INSPECTION REPORT FOR CHANGE OF USE & SYSTEMS PERFORMANCE UNAUTHORISED WORKS - SQUATTERS RUN THREDBOCEIVED - JINDABYNE

CONSENT AUTHORITY:	NSW Dept. of Planning
PROPERTY:	Squatters Run Shop 2 (Unit 34) Mowamba Place Thredbo
INSPECTION DATE:	17/11/15
PHOTOGRAPHS Y/N:	Yes
DESCRIPTION OF UNAUTHORISED DEVELOPMENT:	The sub-floor area at the rear of the above shop is being used as a merchandise storage area, ski tuning workshop and staff tea preparation area/kitchen.
BCA CLASSIFICATION:	Class 6 retail shop and ancillary storage area.
PURPOSE OF THIS REPORT:	To determine the works required to permit the storage space at the rear of shop 2 Squatters Run to be used as part of the shop, i.e, Class 6, comprising storage of merchandise, tea preparation area and boot and ski adjusting area.
TYPE OF CONSTRUCTION:	Type A
REFERENCE:	JAA 1535 REV B dated 5/5/16
COMPLIANCE ISSUES:	An inspection was requested to determine if the sub-floor space at the rear of the shop could be used for its current purpose (described above) and be compliant with the Building Code of Australia 2015 (BCA). Furthermore, that this report be prepared to accompany an application for a Building Certificate for the unauthoris

Figure 1 – Intumescent fire collars are required to be post fitted to plumbing penetrations.

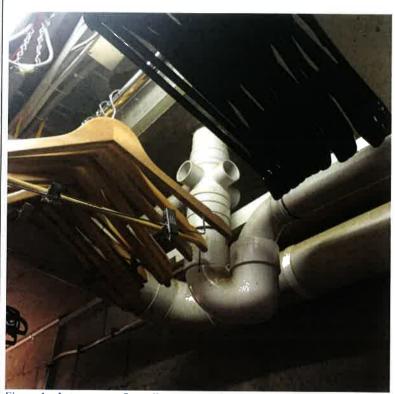
C3.12 Openings in floors and ceilings for services: The floor is penetrated by sanitary plumbing pipework in a number of locations. These penetrations have not been protected with fire resisting covering or the like. Fire collars are required to be installed to each penetration to comply with C3.12 or pipework

enclosed with fire resisting construction.

- 1. Complete retaining wall and provide certification from structural engineer that wall has been completed in accordance with the structural design.
- 2. Fit intumescent fire collars to the PVC pipe penetrations in the concrete slab, in accordance with C3.12 and C3.15 to prevent fire spread to the residential unit above.

Figure 3 - Electrical conduits located in workshop area.

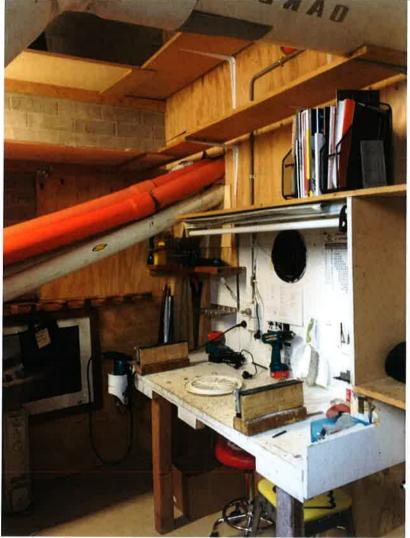
Electrical conduits: the 100 diameter electrical conduits as shown in figure 3 below, may carry high voltage cabling and as such may not be permitted to be located within a workshop area. Advice from Kosciuszko Thredbo with respect to conduits is that a wall must be constructed in front of the pipework to prevent damage.

- 8. Smoke detection in accordance with AS 1670.1-2004 shall be installed in the storage space. The detector/s shall be connected to the building's Fire Indicator Panel and building occupant warning system in accordance with AS 1670.1-2004. Where subject to spurious signals the detector/s install may be thermal type. Audible waring within the space must comply with AS 1670.1 such that occupants of the space must be able to hear the general building alarm in the event of activation.
- 9. Emergency lighting is required to be provided within the building in accordance with AS 2293.1-2005 to illuminate the path of travel to the exit.
- 10. A partition wall is to be constructed between the workshop area and the area containing electrical conduits. A service door is to be

installed in the wall. The door is to be keyed for access by Kosciuszko Thredbo personnel only. 11. Where services or other building elements encroach into the space below 2.2m they are to be highlighted. In order to highlight these reduced head height areas, a strip of high visibility warning tape is to be installed at the lower edge of the services where applicable. This tape will provide warning to very tall occupants that the head height at the bulkhead is low. 12. The recommendations of the FER must form part of the essential safety provisions for the building to ensure the recommendations of this report are complied with throughout the building operation.
CERTIFYING AUTHORITY:	James Alexander
	Accreditation no. BPB0002
	Building Certifier & Fire Engineer ME(Fire Safety)
	B.App.Sc(Bldg)
	Grad Dip Build Surv.
SIGNATURE:	Jamel 18
DECISION DATE:	5 April 2016
Special III of a	·
COMPANY:	James Alexander & Associates P/L
